From: V. Nguyen, G. Abi-Ghanem, M. Villars/EWA Inc.  
Subject: Review of Packing Material Performance  
Date: July 15, 1985

## I. INTRODUCTION

Schematic showing anticipated changes in repository conditions with time (NRC, 1985a)

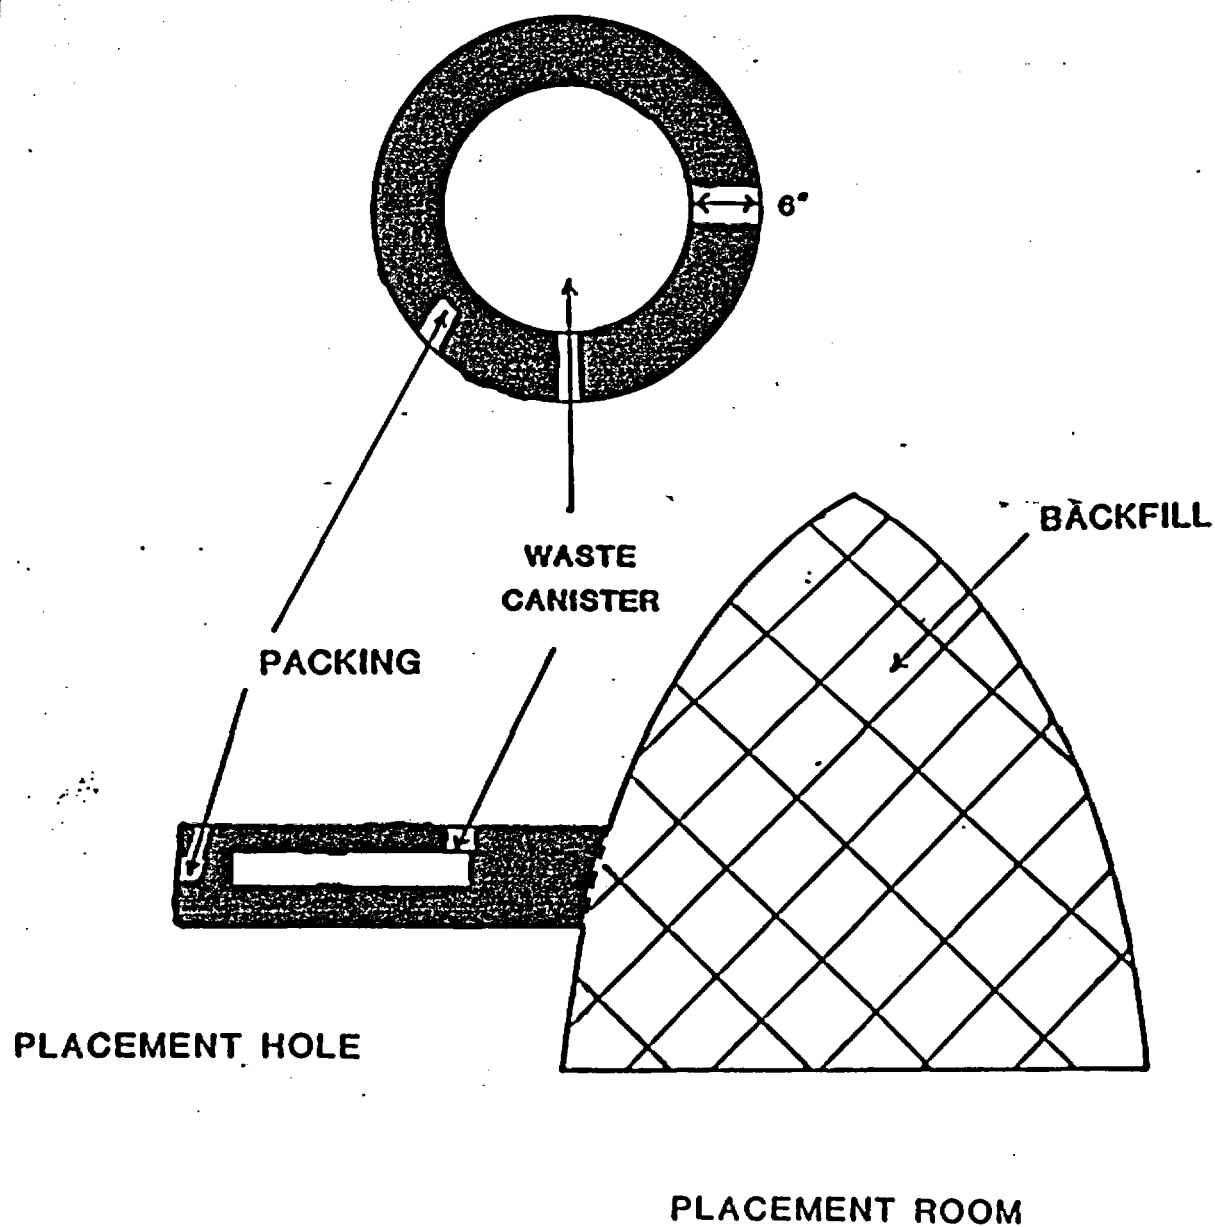
The physical and chemical properties of the packing material must be able to perform these functions. In addition, the packing material must possess sufficient bearing strength to physically support and redistribute the loads and stresses exerted onto it by the surrounding medium, and acceptable thermal conductivity characteristics to assure that it will not irreversibly dehydrate or undergo significant chemical alteration. The material must be able to perform its objectives under a range of pH, redox, temperature, and pressure conditions expected in the repository. Figure 1 gives a summary of anticipated values for these parameters. There is some question about the reliability of these values; as testing and modeling efforts continue, they will require revision. As can be seen, the maximum temperature expected is approximately 300°C, although this will depend
